TVA-WBN-TRM-01-08

**WATTS BAR NUCLEAR PLANT (WBN) UNIT 1 - TECHNICAL REQUIREMENTS
MANUAL (TRM) CHANGE NO. 01-08 - ADDITION OF NEW TECHNICAL
REQUIREMENTS FOR SHUTDOWN BOARD ROOM AIR CONDITIONING (3.7.6) AND
480 VOLT BOARD ROOM AIR CONDITIONING (3.7.7)**

PROPOSED TECHNICAL REQUIREMENTS MANUAL (TRM) CHANGE TRM-01-08 DESCRIPTION AND EVALUATION OF THE PROPOSED CHANGE

PROPOSED TECHNICAL REQUIREMENTS MANUAL (TRM) CHANGE TRM-01-08
REVISED PAGES

Figure 3.7.7-1 (Condition A Combinations):

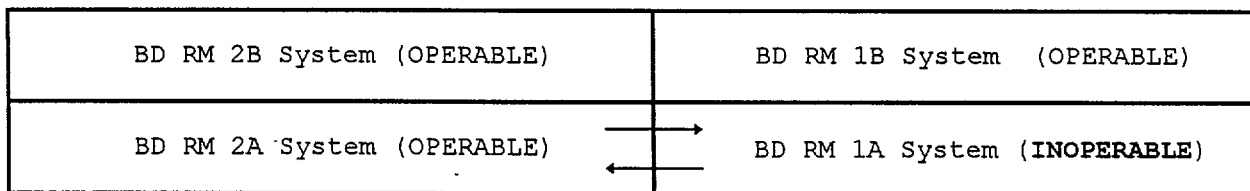
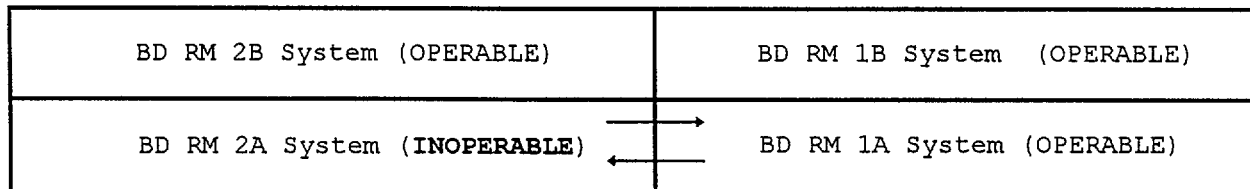
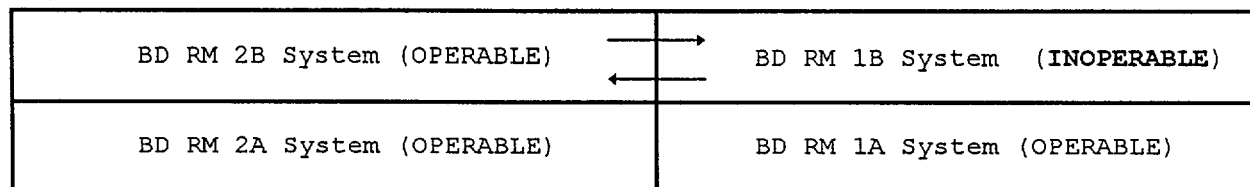
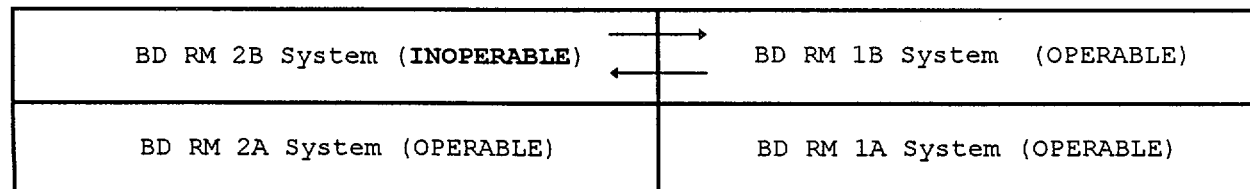
Proposed TR 3.7.7, Figure 3.7.7-1, provides a graphical plan view of combinations of OPERABLE/INOPERABLE 480V board room AC systems acceptable for continued full power operation. Also depicted are the compensatory fan air flow directions between rooms necessary to maintain each within its normal temperature limit defined in TR 3.7.5. These configurations will promote adequate mixing of air between rooms and allow the OPERABLE air conditioning system(s) to cool both rooms. In each case, two portable fans (per door opening) are positioned on the floor such that one is inside the room with the INOPERABLE AC system and the other is inside the adjacent board room with OPERABLE AC. Portable fans, flexible duct, power cables, etc. are conveniently stored so that compensatory measures may be established promptly within expected time frames. Fire breaching permits are required prior to securing the required door in the open position. WBN instructions will specify these compensatory measures, including restoration time frames, selection of doorways, storage and placement of fans and associated flex duct, designated power supplies, etc.

Figure 3.7.7-1 provides a graphical plan view of the acceptable combinations of operable/inoperable 480 volt board room AC systems for continued full power operation with compensatory ventilation fans installed. Also depicted are the compensatory fan air flow directions between rooms in order to maintain each within its normal temperature limit defined in TR 3.7.5. In each case, two portable fans (per door opening) must be positioned on the floor such that one is inside the room with the INOPERABLE AC system and the other is inside the adjacent board room with OPERABLE AC.

Note: Figure 3.7.7-1 illustrates acceptable air flow paths between 480V board rooms when compensatory ventilation fans are installed. Each arrow represents a portable fan/flexible-duct assembly.
